Re: Aurora One – Master Plan Amendment with Adjustment
Application Number: DA-2241-08
Case Number: 2020-7004-01

Initial Submission Review

AURORA ONE PUBLIC IMPROVEMENT PLAN (PIP)

AURORA ONE PUBLIC IMPROVEMENT PLAN (PIP) PLANNING AREAS PA-11 EXHIBIT

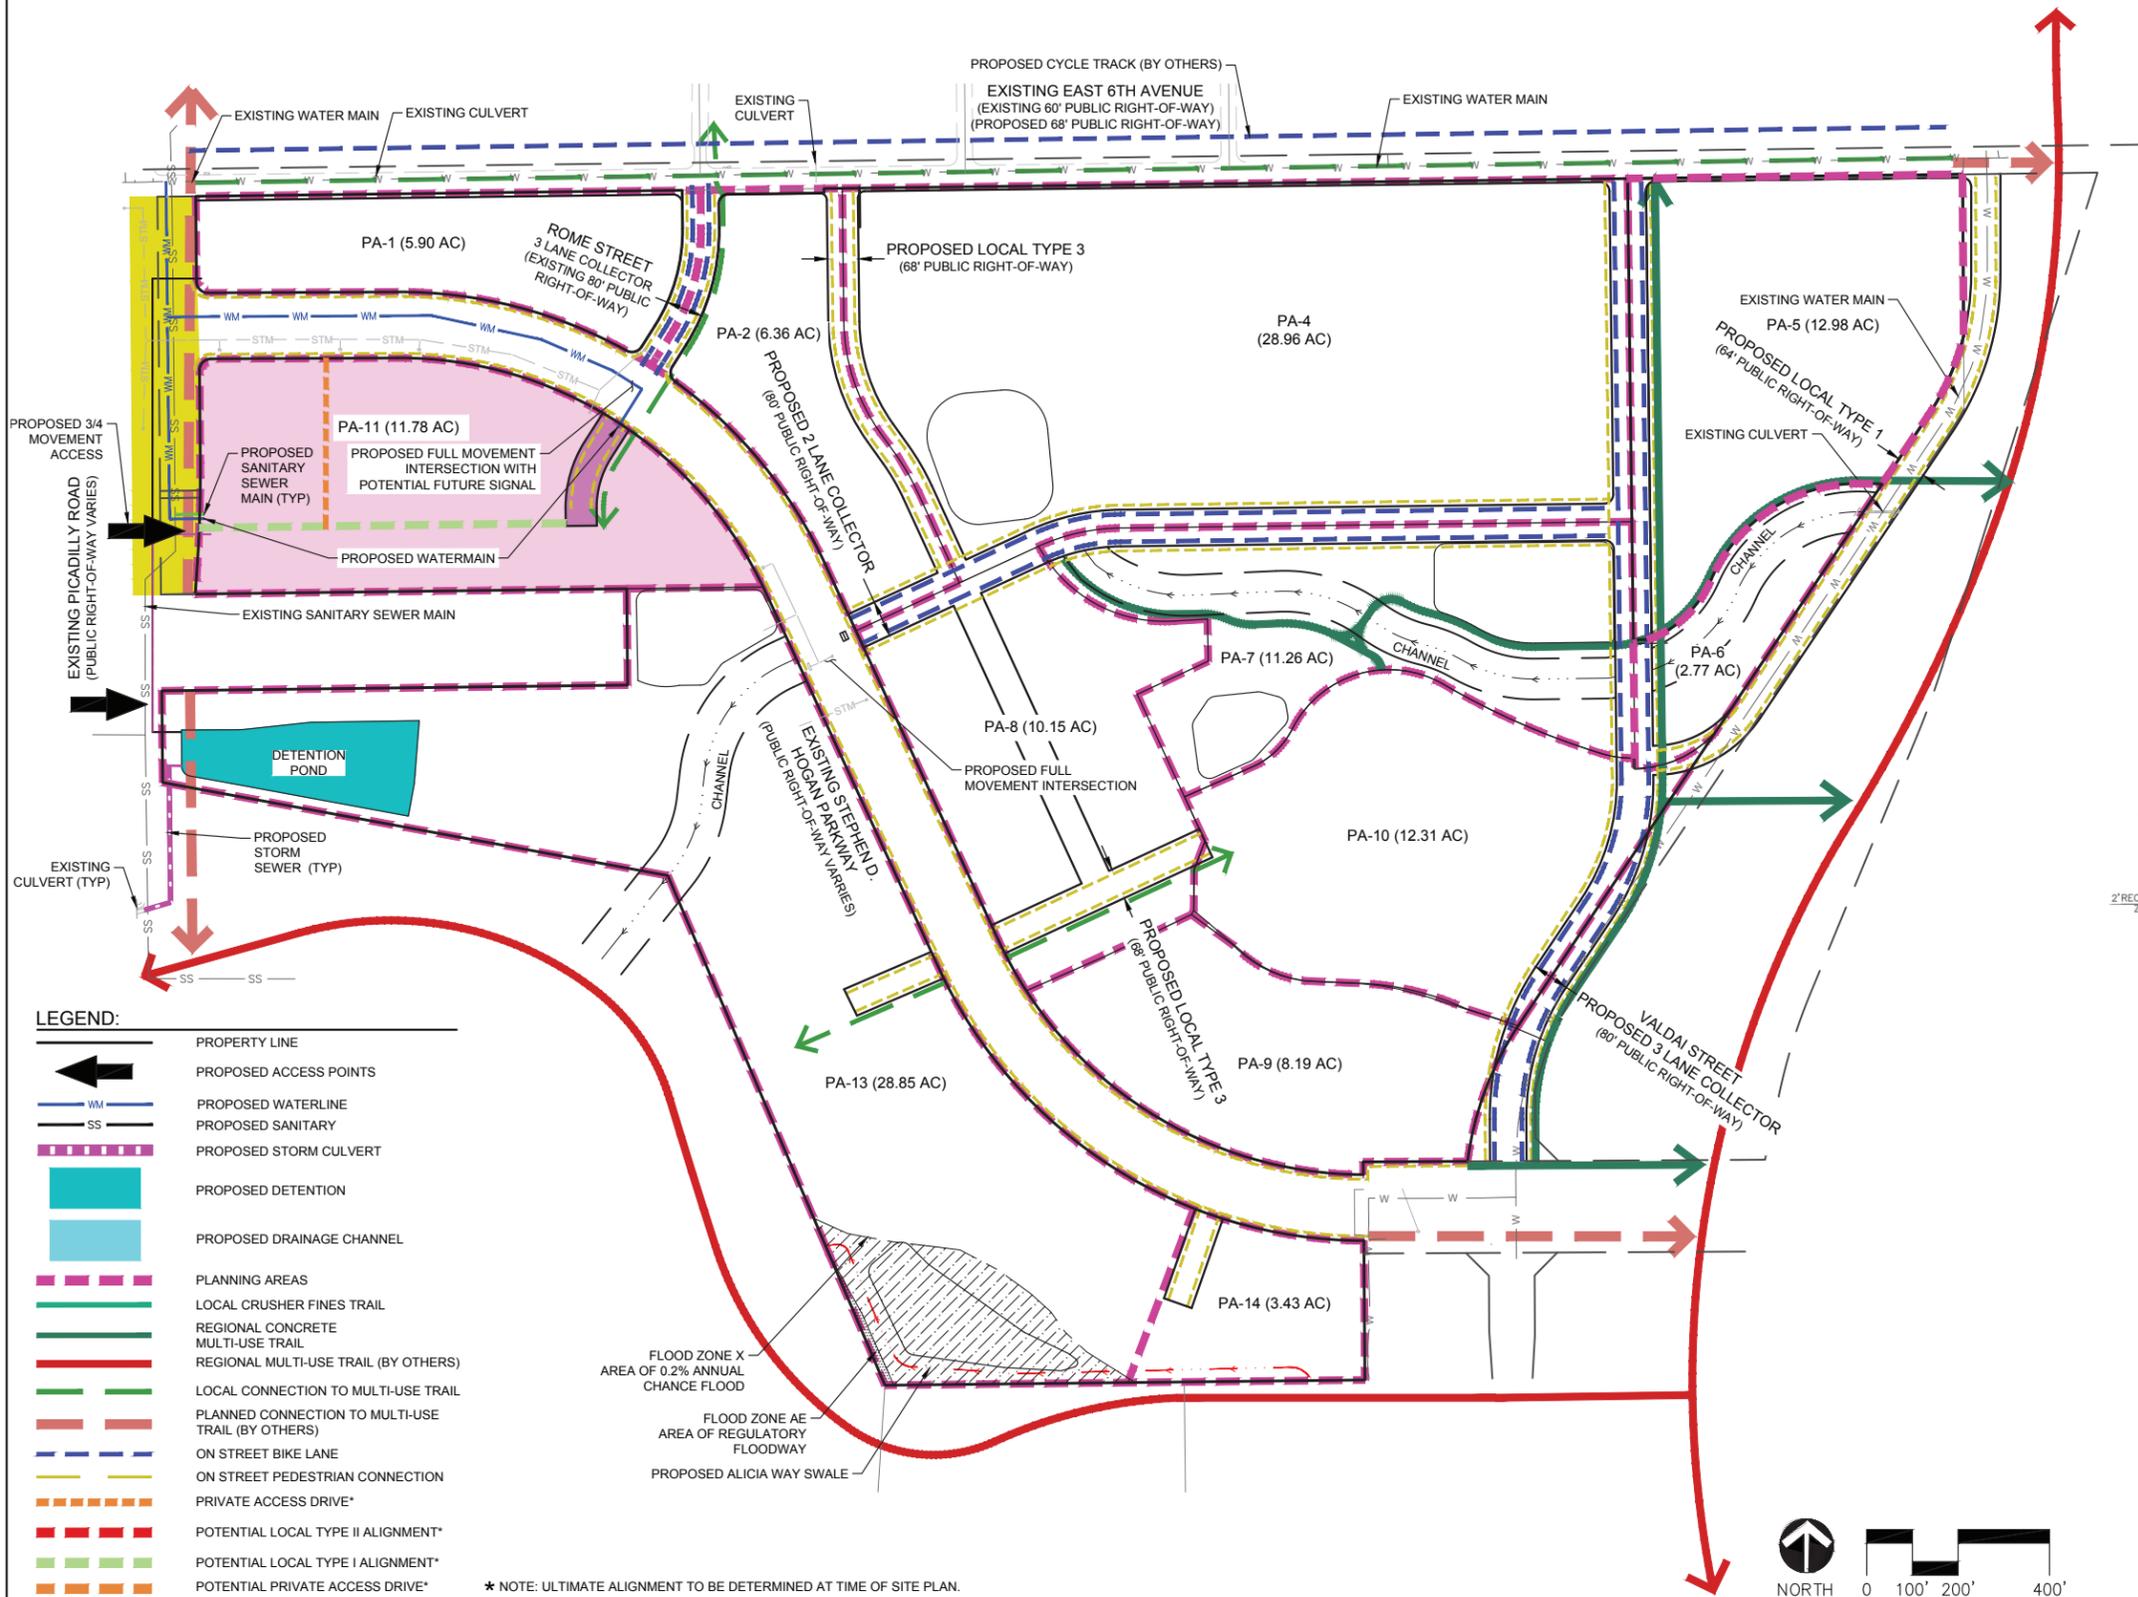
3M. Clarify the limits for Picadilly Road improvements in PA-11 as the exhibit shows it going up to 6th Avenue. *The construction of the eastern half of Piccadilly is required from the south-western boundary of the property to 6th Avenue as a part of the development within PA-11, if not already constructed. The exhibit has been revised accordingly to match.*
